Delegated Report

Householder Planning Application

Application No:	20220363
Location:	7 First Avenue, Northfleet, Gravesend, Kent, DA11 8DJ
Description:	Erection of a dormer in the rear roof slope incorporating 3no. Juliet balconies, conversion of the roof space to form habitable rooms and installation of 2no roof lights in the front roof slope.
Applicant:	Mr & Mrs Liam Dolan
Site Visit:	27.04.22

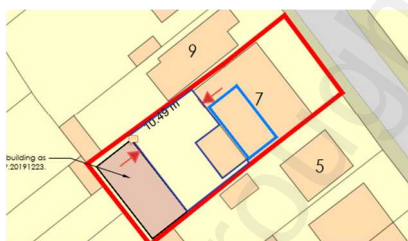
Previously the site has been granted permission for an outbuilding in the rear garden (20191223), a single storey front extension (20090793) and the erection of two storey rear and single storey side extensions (20090375.) The proposed rear dormer would give the appearance of a three storey dwelling from the rear elevation.

As the dormer would be to the rear at the property, it is unlikely to have an impact on the street scene. However, the proposed dormer extension is large and bulky. Although it is set back from the eaves and positioned below the roof ridge line, this does not satisfy the Council's adopted design guidance for roof extensions. As set out by Gravesham Householder Extensions/Alterations Design Guidance SPD (2021), dormers should not overwhelm the roof slope within which they are placed, window position should reflect

the position, design and character of windows at the lower levels and a high standard of design is required. The proposed full width flat roof dormer overwhelms the roof slope and is excessive in size. Aluminium cladding is not in keeping with the host dwelling, the 3no. Juliet balconies are an excessive use of glazing and the window positioning does not sit well with existing windows of the property. It is noted that the design and access statement 3.2.1 explains the windows have been aligned as much as possible, however there is imbalance and a lack of symmetry which means the dormer is not visually attractive. This all adds to the incongruous appearance of the proposed dormer and the cumulative extensions would constitute overdevelopment of the site.
